ATR on Quality Control Check Report. (Bungalows)

Bungalow No	122	QC report stage	PLINTH BEAM	Sl. No.	28023
Company	NILGIRI ESTATES	Project	NILGIRI ESTATES	Phase	II
Prepared by	M.D. FAZAL	Sign	<i>[Signature]</i>	Date	20-09-2017
Project Manager	RADHESHYAM	Sign	<i>[Signature]</i>	Date	20-09-2017
Receipt by QC date		Sign		Other	
Receipt at HO date		Sign		Other	
Checked By MD on		MD Sign		For filling	<input type="checkbox"/> Yes <input type="checkbox"/> No

Quality Control Check Repot. Stage: Before Casting Plinth Beam (Villas)

Plinth Beam Steel check.

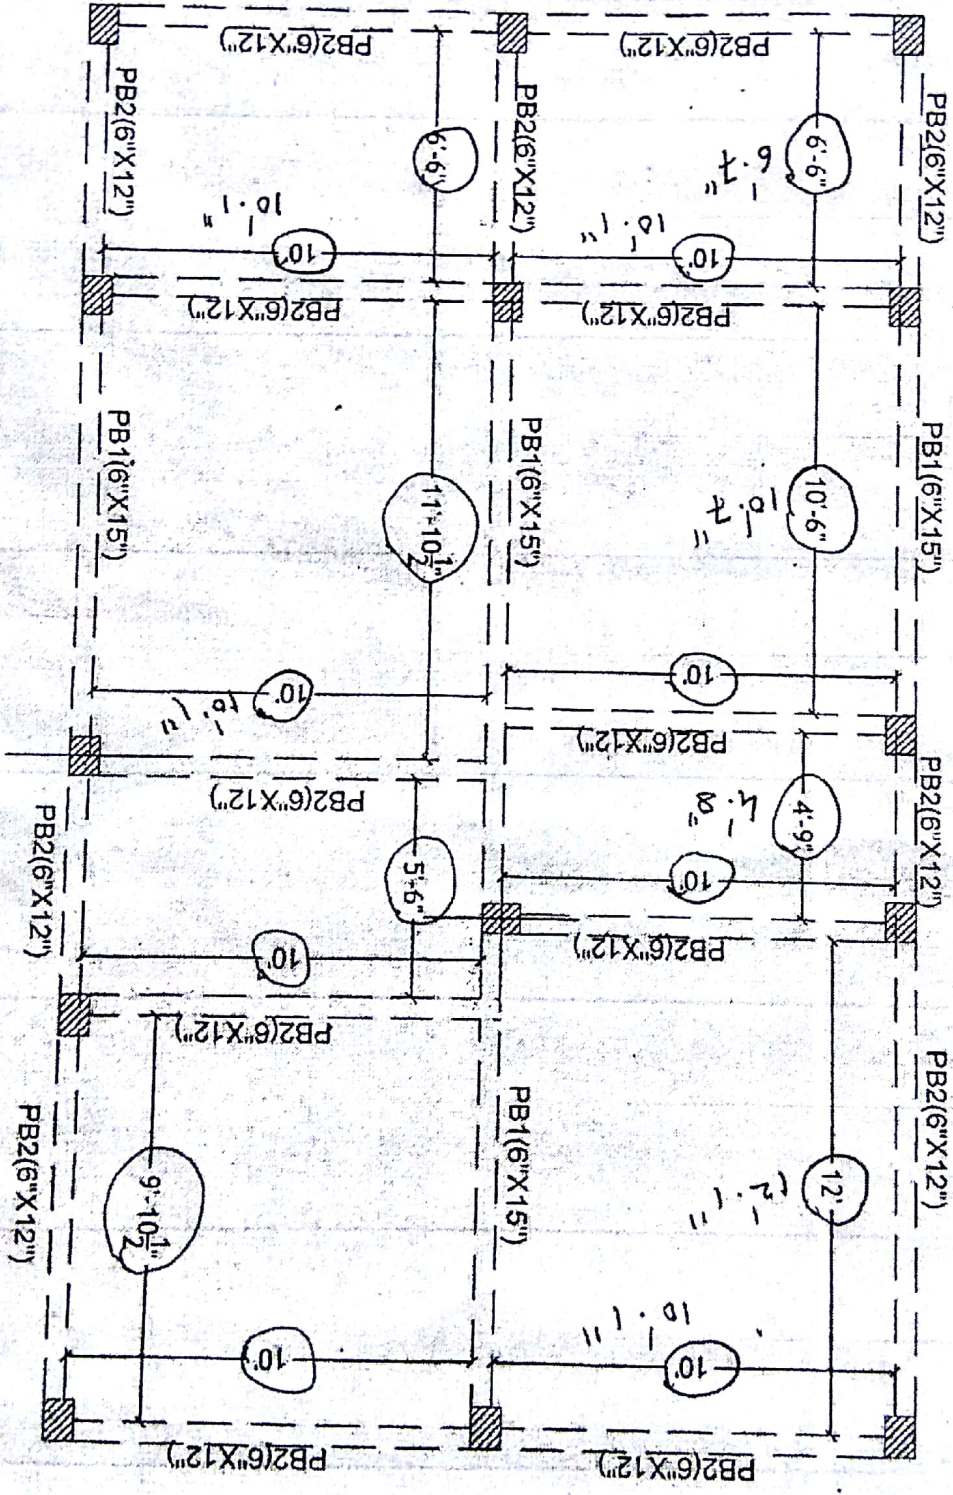
1. Mark ✓ for correct or minor mistake which does not require correction
2. Mark X for minor mistake that requires minor correction.
3. Mark X X for major mistake that requires correction by replacement or re-fixing.
4. Mark X X X for major mistake that cannot be corrected.
5. Columns overlapping length should be 45 to 50 D.

S No	Item	Quantitative Check (✓ or X)	Qualitative Check (Good / Avg. / Bad)
1.	Steel Check - Beam no of rods	✓	<input checked="" type="checkbox"/> Good <input type="checkbox"/> Avg. <input type="checkbox"/> Bad

2.	Steel Check - Beam size of bars	✓	<input checked="" type="checkbox"/> Good <input type="checkbox"/> Avg. <input type="checkbox"/> Bad
3.	Steel Check - Beams Extra Bars	✓	<input checked="" type="checkbox"/> Good <input type="checkbox"/> Avg. <input type="checkbox"/> Bad

4.	Steel Check - Beams Overlapping & Cranking	✓	<input type="checkbox"/> Good <input checked="" type="checkbox"/> Avg. <input type="checkbox"/> Bad
5.	Steel Check - Beams Bearing	✓	<input type="checkbox"/> Good <input checked="" type="checkbox"/> Avg. <input type="checkbox"/> Bad

6.	Covering blocks for beams	✓	<input type="checkbox"/> Good <input checked="" type="checkbox"/> Avg. <input type="checkbox"/> Bad
7.	Depth and width of beams	✓	<input type="checkbox"/> Good <input checked="" type="checkbox"/> Avg. <input type="checkbox"/> Bad
Remarks:

Remarks: WORK COMPLETE AND ADJUSTED

Certified that all corrections mentioned in the QC report have been completed. Work can proceed to next stage.
